Markets Committee

Committee(s):	Date(s):
Markets Committee	30 November 2016
Streets & Walkways Sub-Committee For Decision	6 December 2016
Subject: North – South Cycle Superhighway Phase 2: The City’s response	Public
Report of: Director of the Built Environment	For Information
Report Author: Sam Lee	
<p style="text-align: center;">Summary</p> <p>TfL, on behalf of the Mayor of London, carried out a public consultation exercise on proposals to extend their North – South Cycle Superhighway to Kings Cross in early 2016. A number of major concerns were expressed by the City. However, since then, TfL has worked with City officers to improve the proposals. The current layout, which is under further consultation, addresses most of the City’s concerns but a few minor issues remain.</p> <p>Officers consider that the revised proposals offer substantial safety benefits, good and safer cycling route connectivity between the Cycle Quietways and the Cycle Superhighway and provide for the much needed pedestrian crossing facilities at the Farringdon Street/West Smithfield and the Farringdon Road/Charterhouse Street junctions. However, the SMTA and the Markets and Consumer Protection Department have

Banned left turn into West Smithfield except cycles

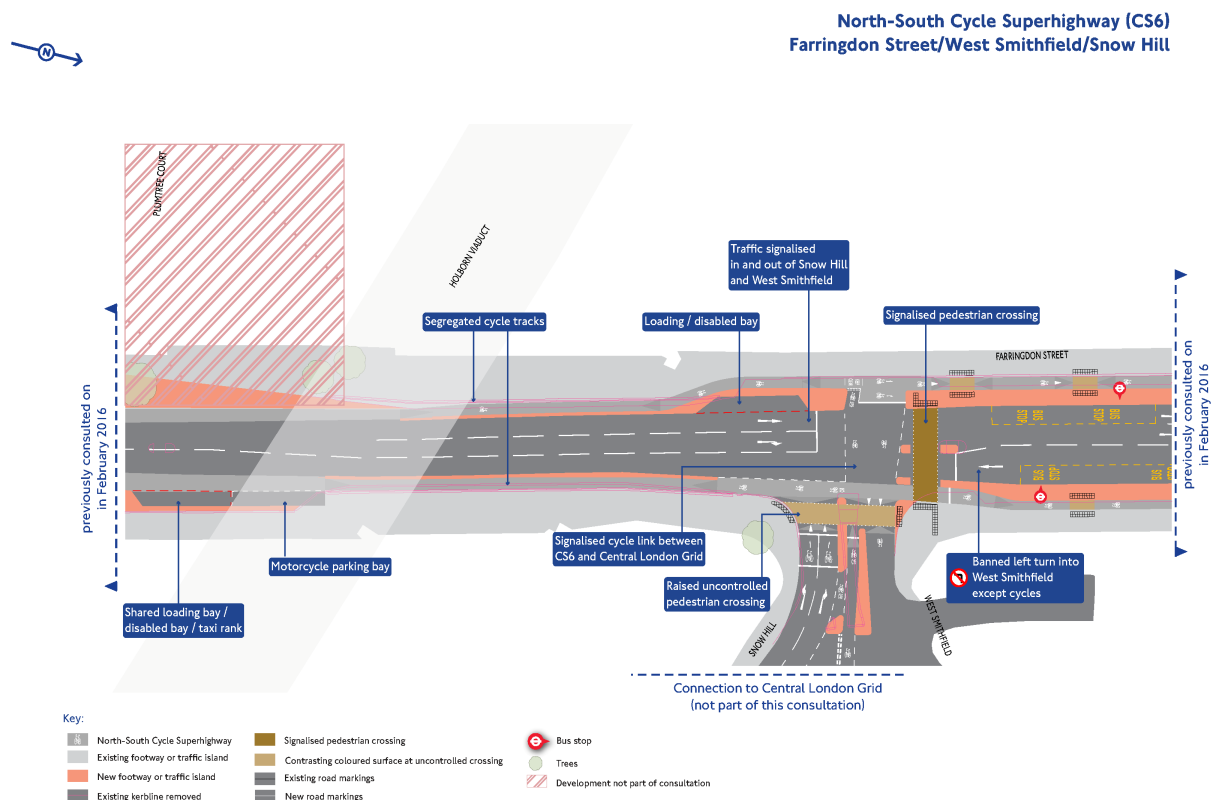
- A banned turn for southbound traffic turning left from Farringdon Street into West Smithfield to remove the risk of 'left hook' conflicts

between turning motor vehicles and cyclists travelling ahead at the junction

- Traffic counts show that a maximum of 40 vehicles per hour make this movement. Alternative routes are available nearby

Sheet 25 OF 27

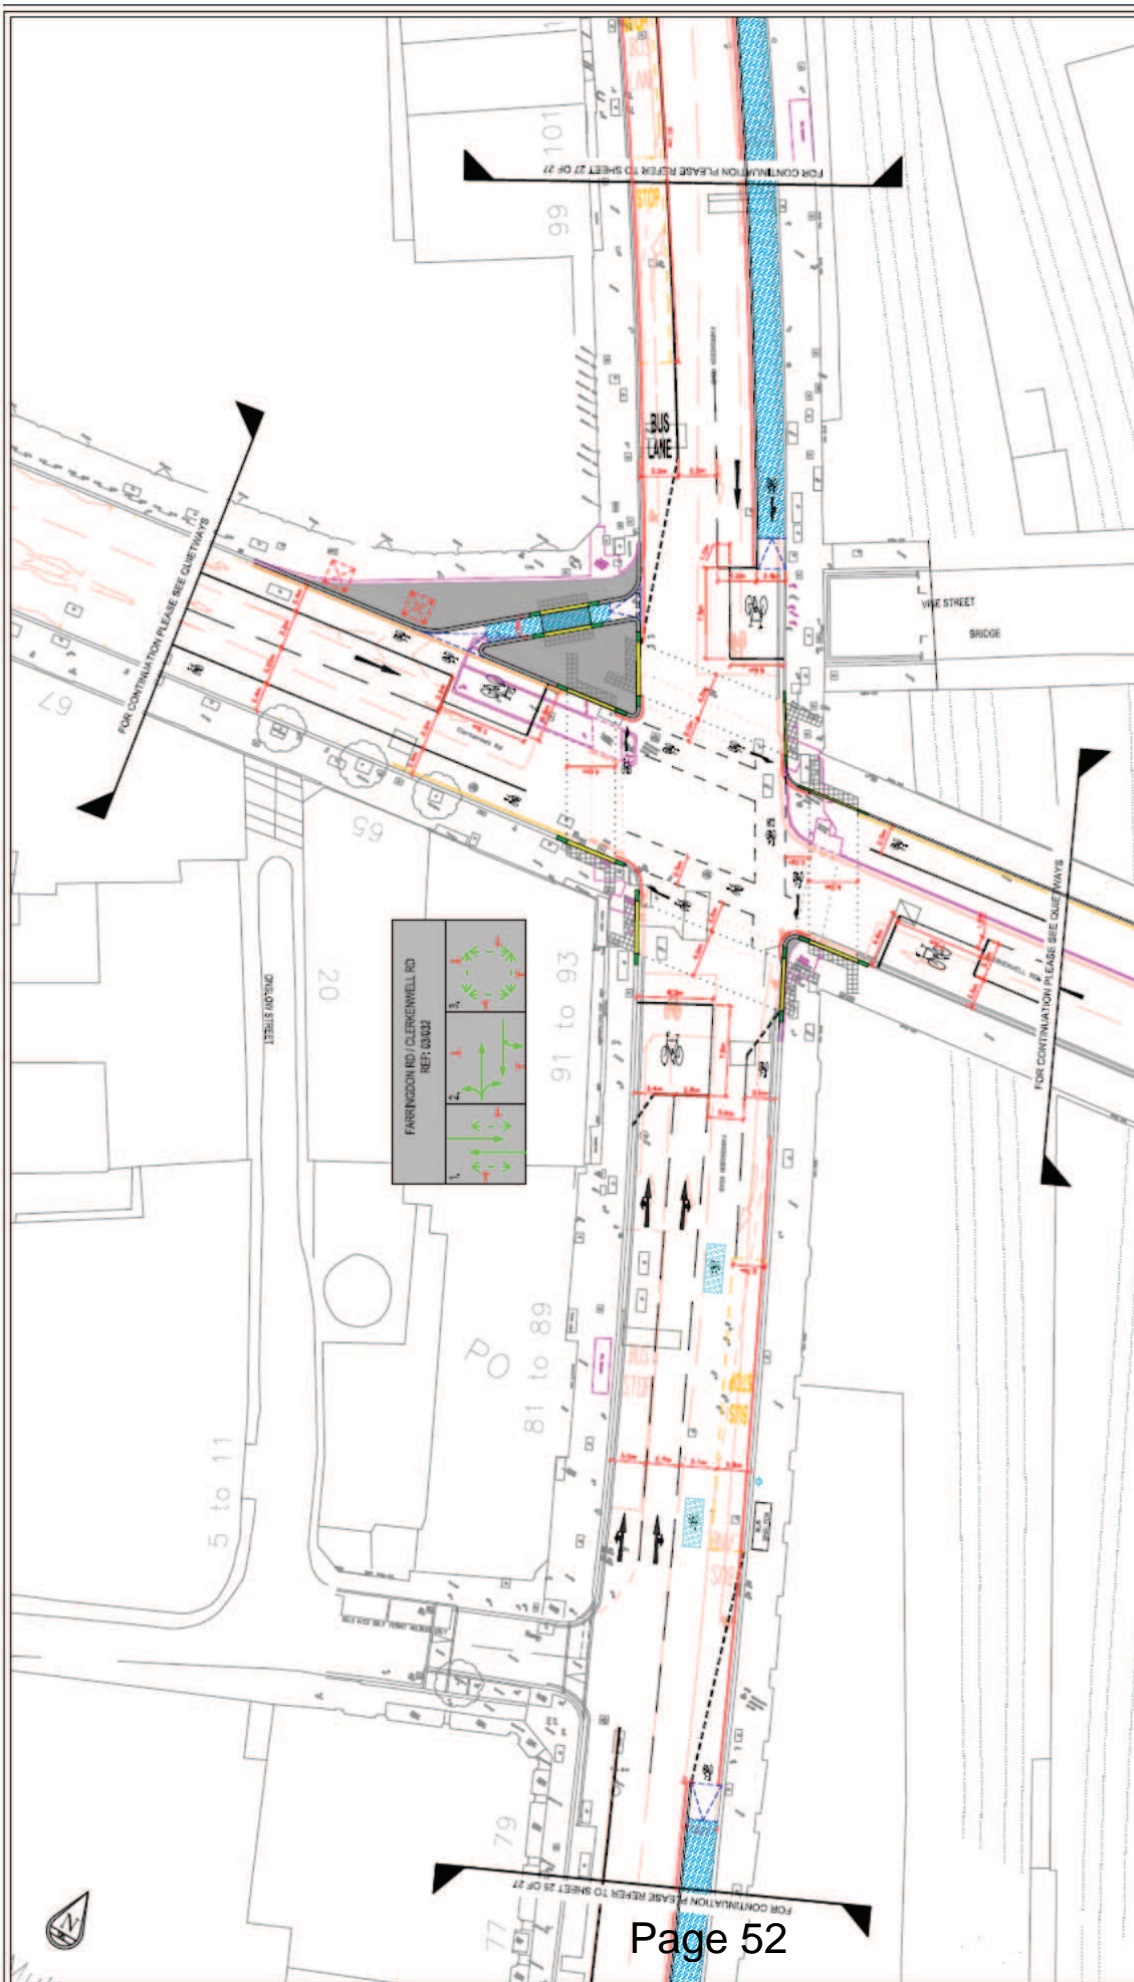
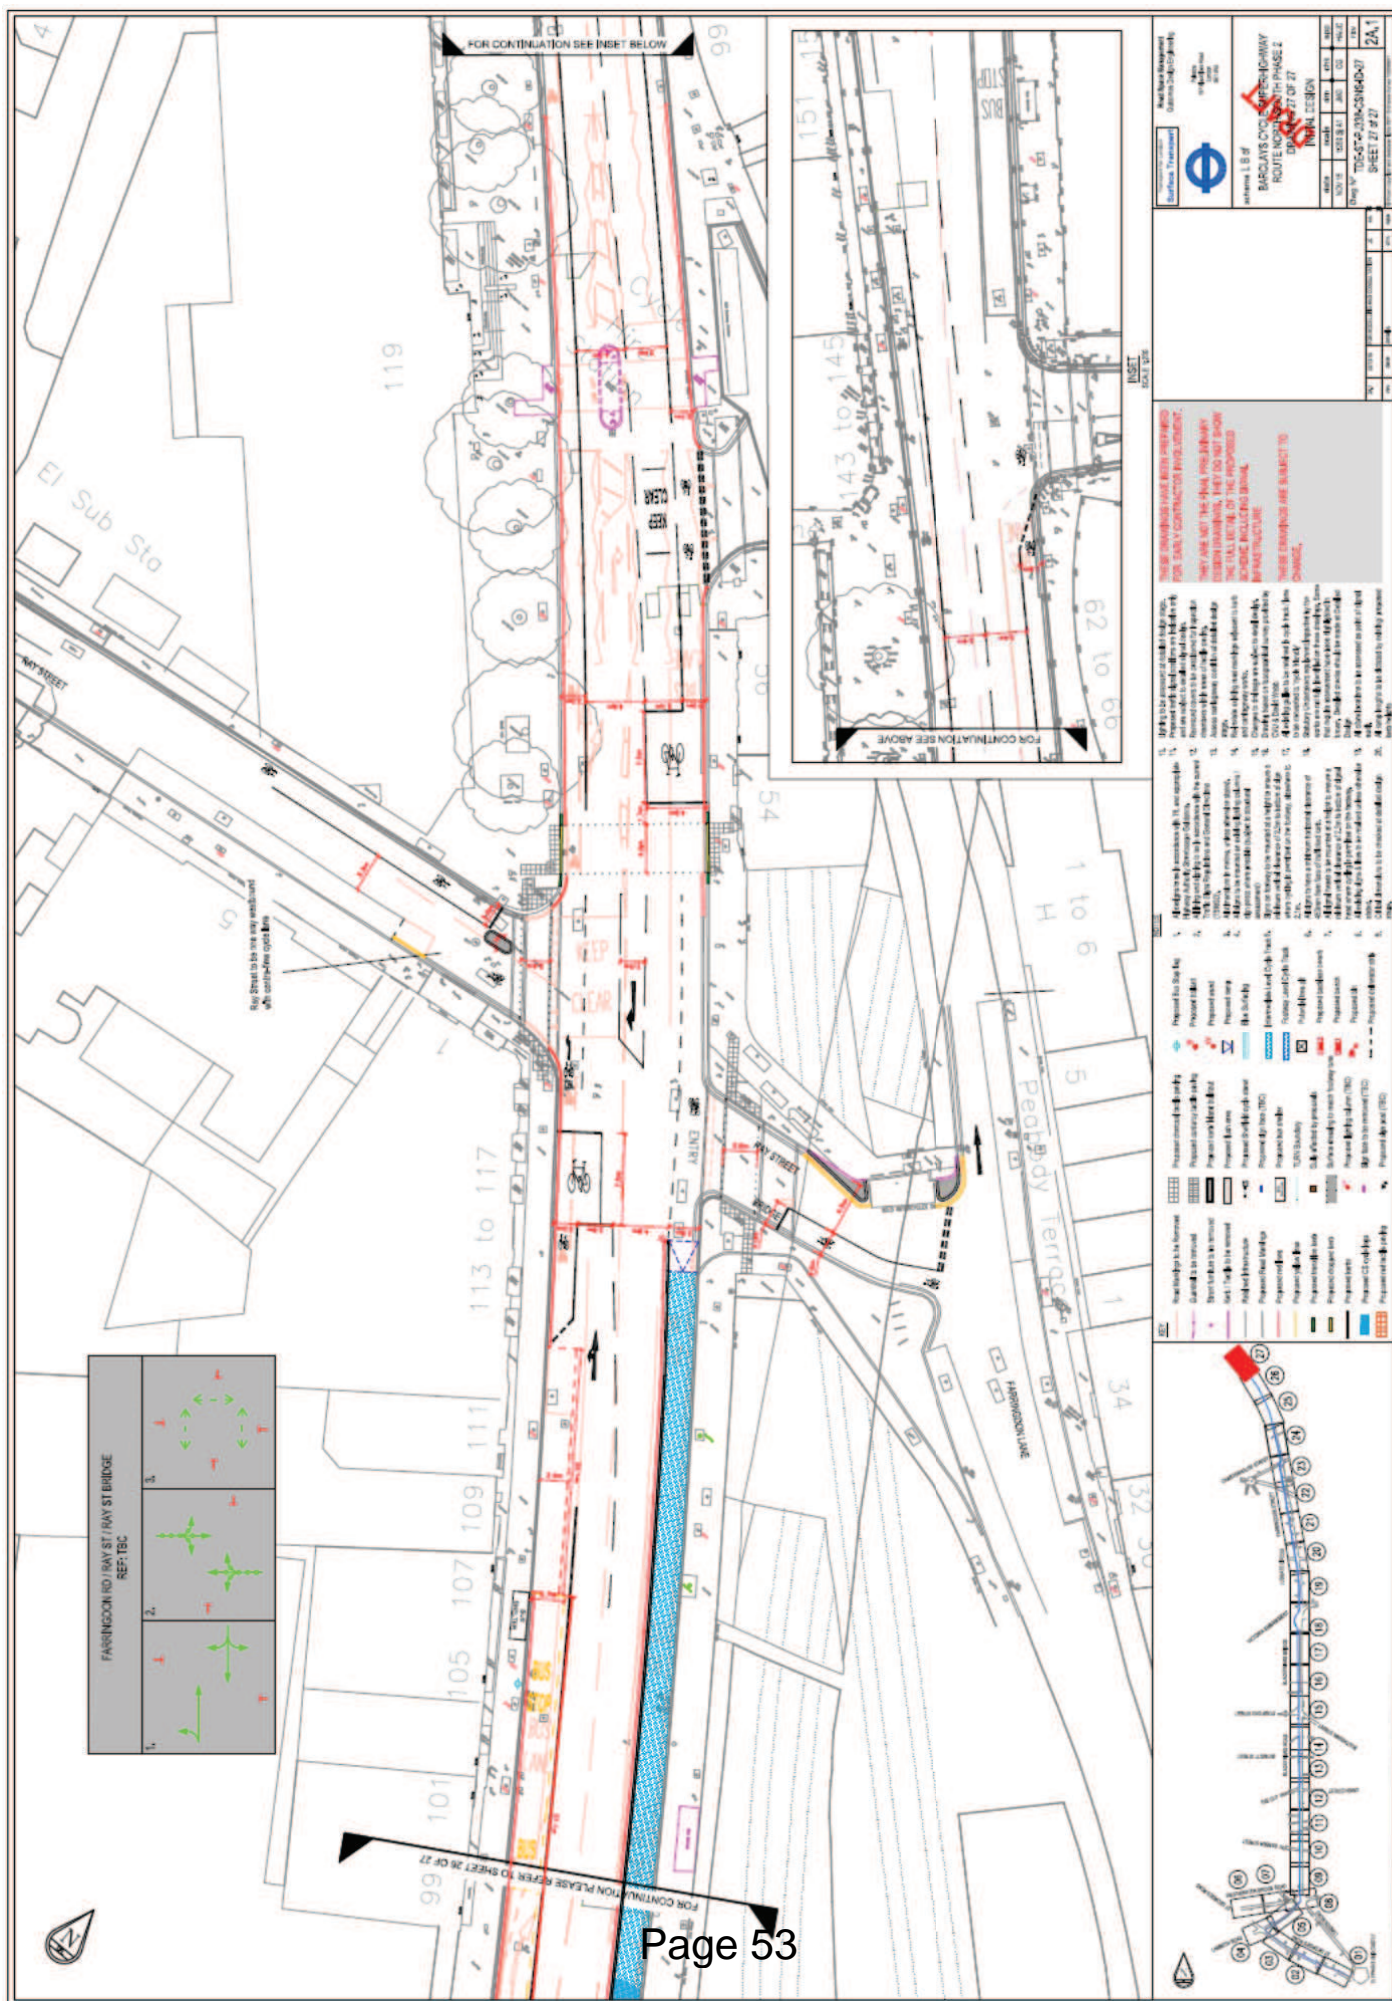
It is proposed to provide battered kerbs for powered two wheelers to cross the cycle track and access the parking bay. The Audit Team are concerned that riders of powered two wheeled vehicles may attempt to access the parking bay at an acute angle, and the presence of the battered kerb may destabilise the rider. An exacerbated potential for the rider to become unseated, with an associated potential for personal injury may exist as a result.

Provide a smoother transition for powered two wheelers to access the parking bay. This may require the provision of a conventional dropped kerb or other similar measure.

Ensure cyclists are located in a position to observe the primary traffic signals for the manoeuvre they wish to undertake. If this cannot be achieved it may be beneficial to provide additional cycle specific traffic signals at the position they are most likely to be observed.

It is proposed to provide a pedestrian crossing at the junction with Stonecutter Street together with a crossing for cyclists to tie into the end of the bi-directional cycle track. Cyclists using the cycle track and pedestrians crossing west-east are likely to reach the central island at broadly comparable times if they proceed concurrently. This may lead to pedestrians attempting to crossing into the path of cyclists. It may be beneficial to allow cyclists a number of seconds head-start so they clear the junction and the pedestrian crossing point before pedestrians reach the central island.

It is proposed to provide a bus shelter within the floating bus stop island. It would appear that the bus shelter is located in close proximity to the cycle track. It may be beneficial to ensure adequate lateral clearance is provided to the rear of the shelter to ensure the feature does not pose a hazard to cyclists.

It is proposed to provide a segregated island with a wand at the commencement point of the northbound segregation on Farringdon Street. This island and wand appears to be within the swept path for vehicles turning left from Charterhouse Street. It may be beneficial to relocate the island after the pedestrian crossing to reduce the potential for the island to be struck by turning vehicles.

It is proposed to provide an uncontrolled pedestrian crossing facility across the cycle track on Greville Street. Due to the number of pedestrians likely to use this footway it is highly likely that pedestrians will cross without giving regard to the presence of cyclists. Whilst unlikely to result in personal injury due to the very low speed cyclists will need to be travelling to make this manoeuvre. It may be beneficial to provide measures to facilitate cyclists to pass through Greville Street less impeded. At peak times the number of cyclists waiting to pass may block the facility for other cyclists.

Design Organisation Response	Accepted
<p>Accepted: The current proposals show an angled 150mm wide kerb but given the concern noted, the new proposed angled kerb is 300mm wide with the same 50mm upstand. (See Rev2A.2 drawings)</p> <p>An example of the angled kerbs is shown in the image below. These have a gradient of 1 in 6 because the whole kerb is angled rather than just the edge battered. This type of solution will be recommended to the detailed designers.</p>

Client Organisation Comments
Accepted. Agree with designer's response.

Design Organisation Response	Rejected
<p>Rejected: Findings from the TfL trials outlined that the optimal position for the signal for two-stage turns is a far sided secondary signal. This layout has already been applied at many other junctions across London within the Cycle Superhighway and Better Junction programmes and is continued on CSNS for consistency.</p> <p>Two-stage right turn facilities will be monitored as part of the Cycle Superhighways Monitoring Strategy. If this reveals that alterations need to be made to their operation and/or layout then locations along CSNS will be updated to reflect this.</p>	
Client Organisation Comments	
Agree with the designer's response.

Design Organisation Response	Part Accepted
<p>Part accepted: The majority of southbound cyclists will have passed the uncontrolled pedestrian crossing before the westbound pedestrians reach it. The distance for cyclists is 26m and at a slow speed of 12km/h this would take them 7.9s. The crossing pedestrians have to cover 19m but at a slower speed of 1.2m/s this would take them 15.8s. In addition, the shorter intergreens to the cycle crossing mean that cyclists do get a green signal one second before the pedestrians.</p> <p>This uncontrolled section of the crossing will be constructed with ducts to enable a conversion to signal control should the issue be realised. Monitoring will take place once all of the developments in the area are complete and pedestrian and cycle flows are established.</p>	
Client Organisation Comments	
Agree with designer's response. When released from the southbound stop line, cyclists will clear the crossing area much quicker than pedestrians crossing from the eastbound side in the same phase.

Accepted. Agree with the designer's response. The provision of additional pedestrian crossings at Charterhouse Street and wider footways in the area, including on Greville Street where the road is proposed to be closed, will provide more space for pedestrians to distribute leading to fewer people crossing the cycle track on Greville Street.

Appendix 9 (1 of 2) - Banned Right Turn : Alternative Routes

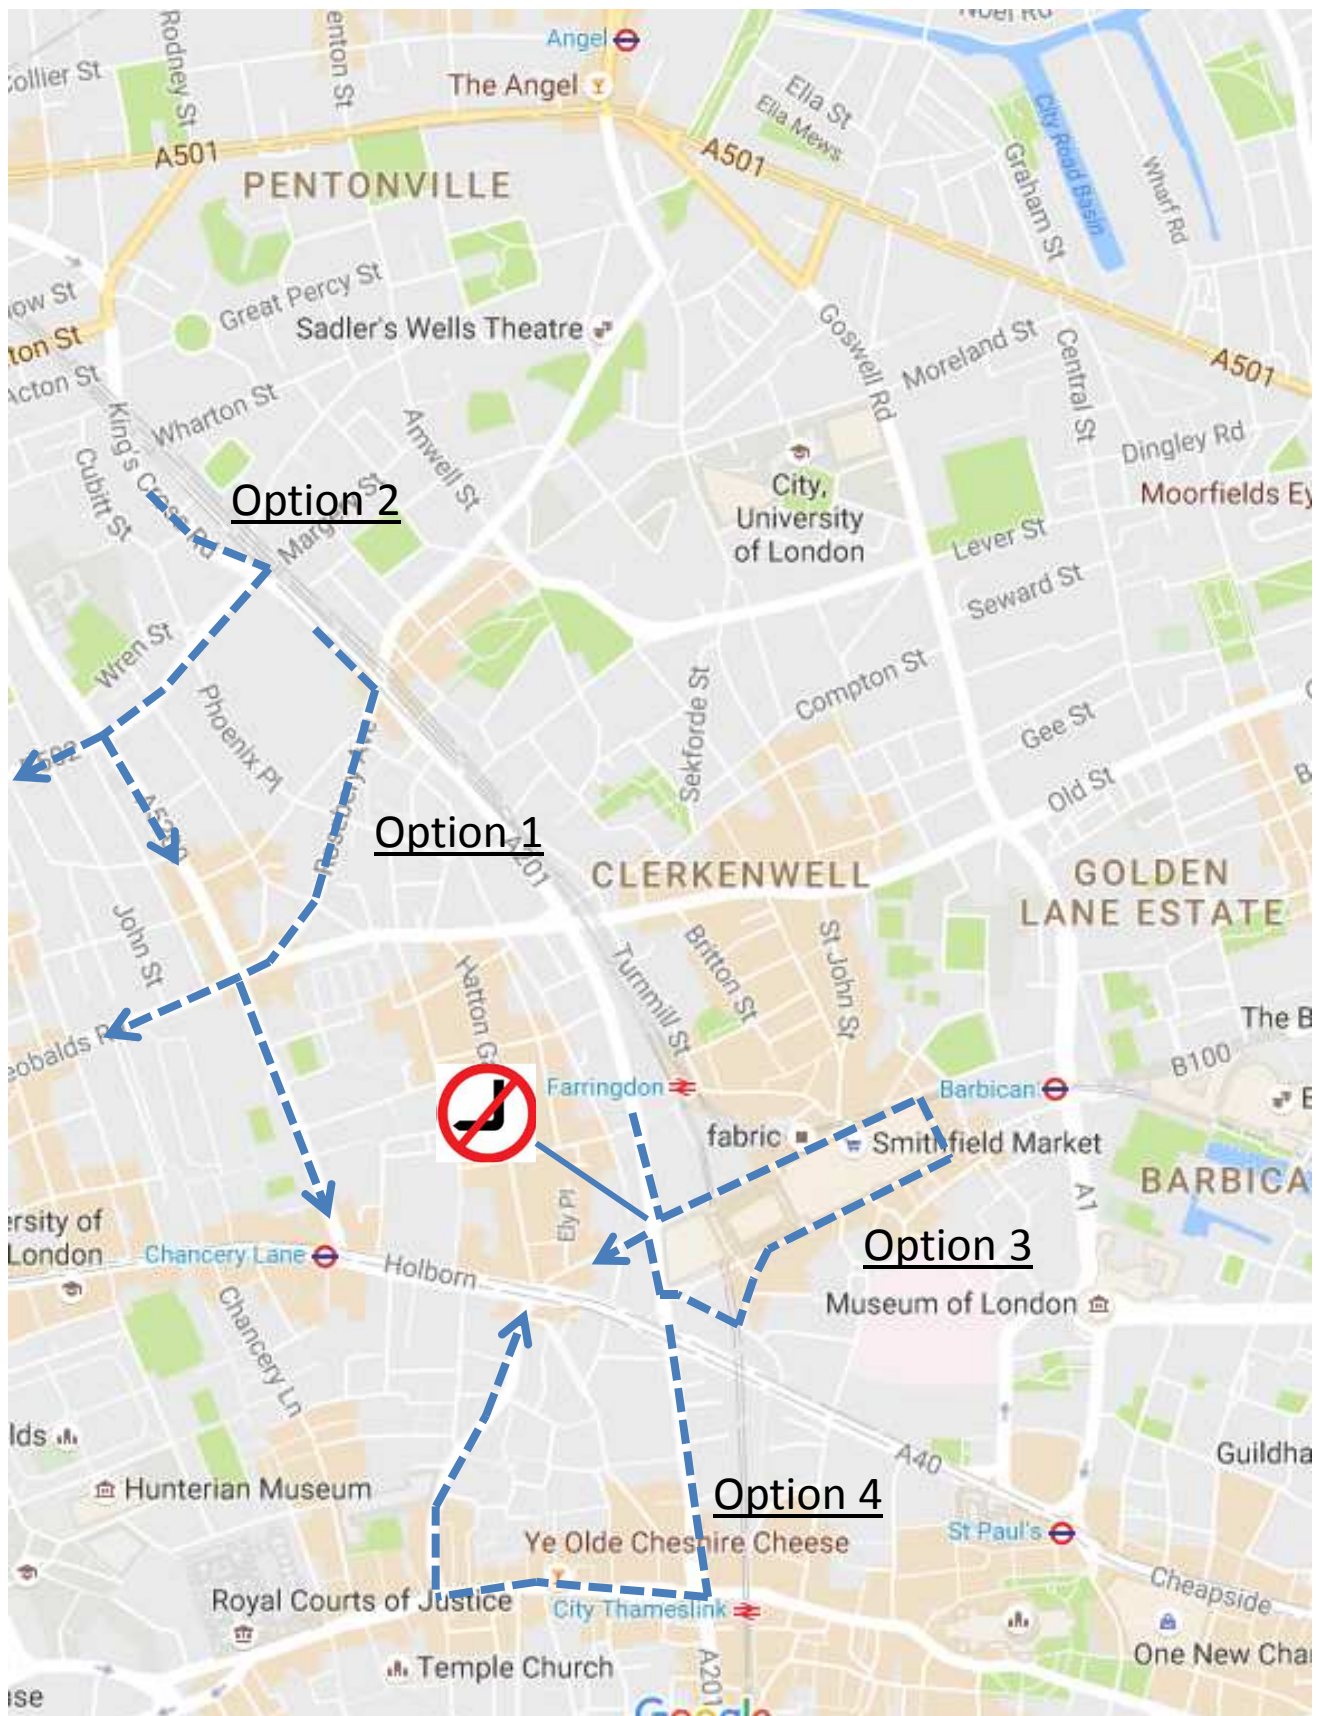
- 15. The level of southbound right turning traffic into Charterhouse Street (west) is also low when compared to the other movements. The average daily (24hrs) weekday flow is 1,820 vehicles. A summary of the traffic flows around the Market are shown in Appendix 8. A full set of traffic count data can be supplied to Members on request.

- 16. The nearest and simplest diversionary routes for both banned turns would be to turn left into Charterhouse Street (east) and to proceed around the market. Alternatively, traffic can continue down Farringdon Street and then turn left or right at Ludgate Circus and then use other City streets to reach their destination. There are also other good diversionary routes available further north, such as using Rosebury Avenue, the Inner Ring Road, and other streets. These routes would be more appropriate for some of the diverted traffic. Appendix 9 provides a map of the diversionary routes.
